4.1 **8 PALMERSTON CRESCENT, SOUTH MELBOURNE**
LOCATION/ADDRESS: **8 PALMERSTON CRESCENT, SOUTH MELBOURNE**
GENERAL MANAGER: **CLAIRE FERRES MILES, PLACE STRATEGY & DEVELOPMENT**
PREPARED BY: **GRANT LOGAN, MAJOR PROJECTS & APPEALS ADVISOR**

1.1 To determine Council's position in the upcoming Victorian Civil and Administrative Tribunal (VCAT) compulsory conference and hearing for Planning Permit Application 606/2017.

01 LODGED APPLICATION

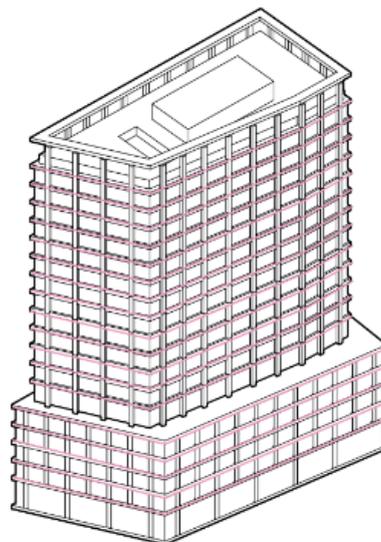
The applicant considers the current design to provide a better design outcome than the parameters of the DDO setbacks, particularly given the unique dimensions and street interface of the site.
